REMARKS

Appl. No. 10/085,129
Amdt. Dated June 15, 2004
Reply to Office Action of Jan. 15, 2004
Annotated Sheet Showing Changes

Fig. 2

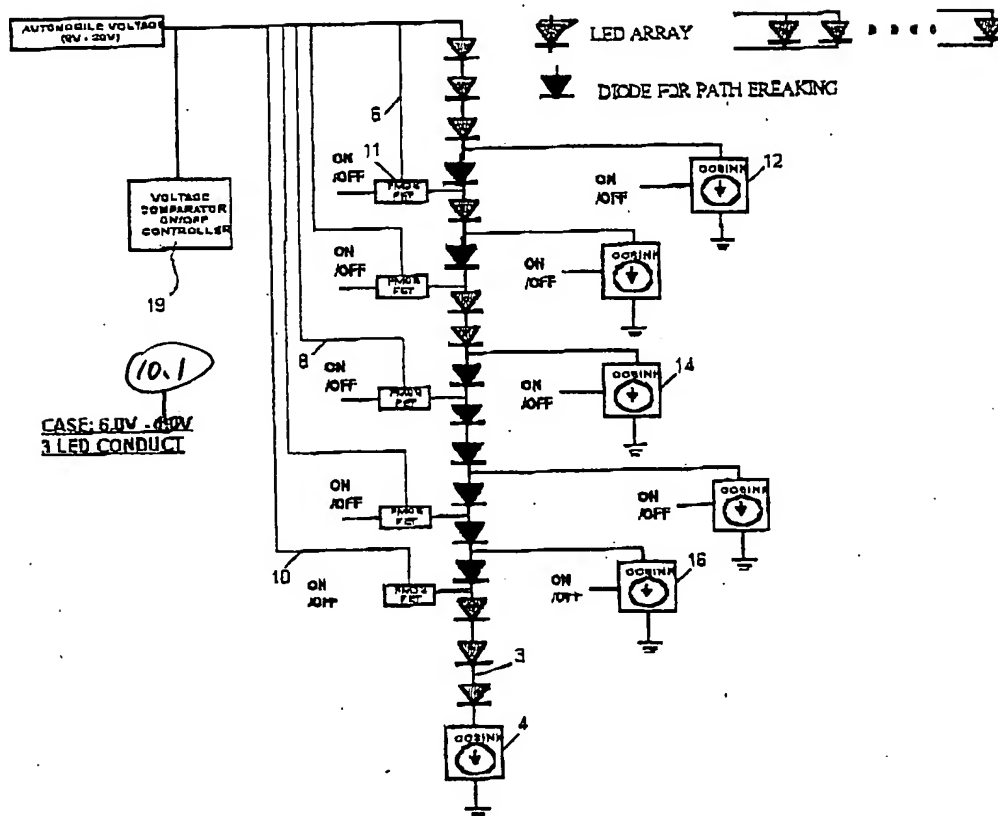
Figs. 1 – 2 of the application have been objected as containing certain clerical errors. Figs. 3 – 5 of the application have been objected as failing to comply with 37 CFR 1.84(p)(5) because they do not include proper reference signs.

Applicant respectfully submits that the amended Figs. 1 – 6 have corrected the clerical errors and provided reference numerals. More specifically, in Fig. 1, the lead lines for numeral 18 have been provided. In Figs. 1 – 6, the symbols for Array LEDs and Path Breaking Diodes are clearly distinguished. In Fig. 2, the caption has been corrected to indicate the proper range is “6.0V – 10.1V.” In Fig. 3, the missing reference numeral 11 has been added. In Fig. 4, the missing reference numerals 8 and 19 have been added. In Fig. 5, the missing reference numeral 19 has been added. In addition, in Figs. 1 – 6, a connection line has been added between the PMOFET of path 10 and the nearby line between LED Array 18 and Path Breaking Diode 2 to complete a circuit with the constant current device 4 (See page 9, line 13). No new matter has been added by the above amendments.
